SUBJECT: COMANCHE PEAK NUCLEAR POWER PLANT, UNITS 3 AND 4
DOCKET NUMBERS 52-034 AND 52-035
RESPONSE TO REQUEST FOR ADDITIONAL INFORMATION NO. 4308, 4309, 4310,
AND 4311

Response to Request for Additional Information No. 4308 (CP RAI #138)

QUESTIONS for Hydrologic Engineering Branch (RHEB)

DWG. NO. FN-SCR-4

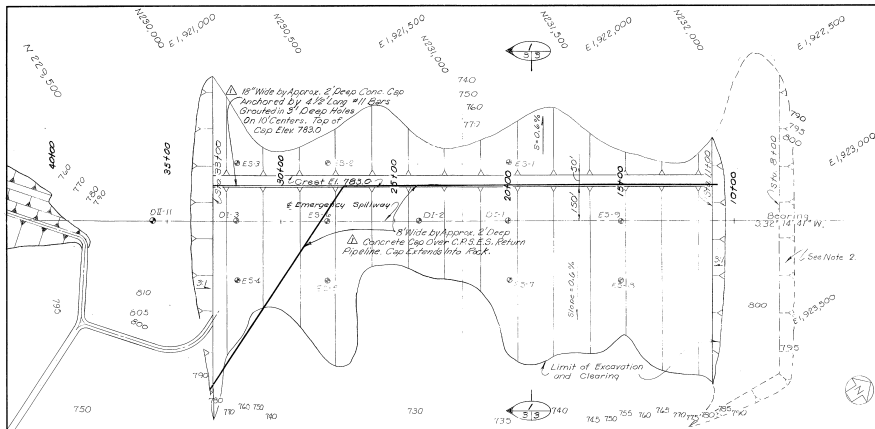
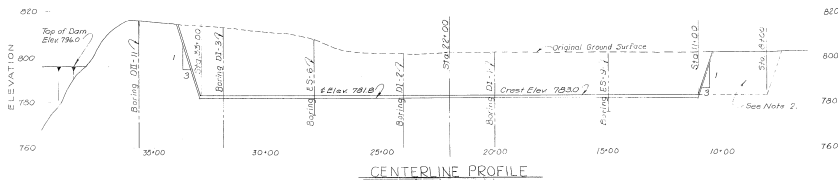
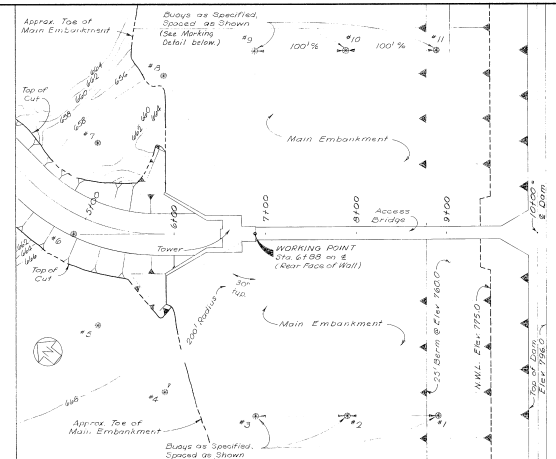
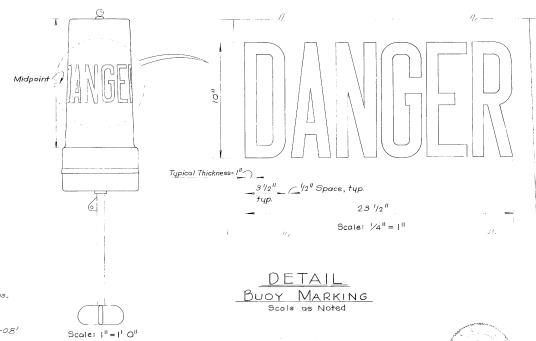
QUESTION NO.: 02.04.03-6

Accordingly, the NRC staff requests that the applicant provide:

In addition, the calculation has been revised to reflect new spillway discharge rating curves utilizing the methods of the U.S. Bureau of Reclamation Design of Small Dams for the service spillway with an ogee crest and the methods of the Federal Highway Administration Hydraulic Design Series Number 5 for the emergency spillway. The reconstituted spillway discharge rating curves are more conservative than those previously used and account for submergence due to assumed tailwater effects.

For the 100-ft wide service spillway with an ogee crest elevation of 775 ft, a design head of 25 ft, or elevation 800 ft, was selected. This is more conservative than the recorded design head of approximately 15 ft. Based on the record drawing approach height for the spillway of 12 ft, the ogee crest discharge coefficient is determined to be 3.78. Accounting for the depth of overtopping flow up to elevation 795 ft, the ogee crest discharge coefficient is reduced to range from 3.02 to 3.67 for an overtopping depth from 1 ft to 20 ft. Because the ogee crest has a 45 degree sloping upstream face, the ogee crest discharge coefficient is increased to range from 3.06 to 3.71.

The revised backwater analysis as discussed in the response to Question 02.04.03-5 above determined that the water surface elevation on the downstream face of the Squaw Creek Dam would reach elevation 760.39 ft. This elevation is below the ogee crest spillway, indicating no submergence due to tailwater effects would occur. However, the conservative assumption that the spillway crest is submerged is retained for the PMF analysis.
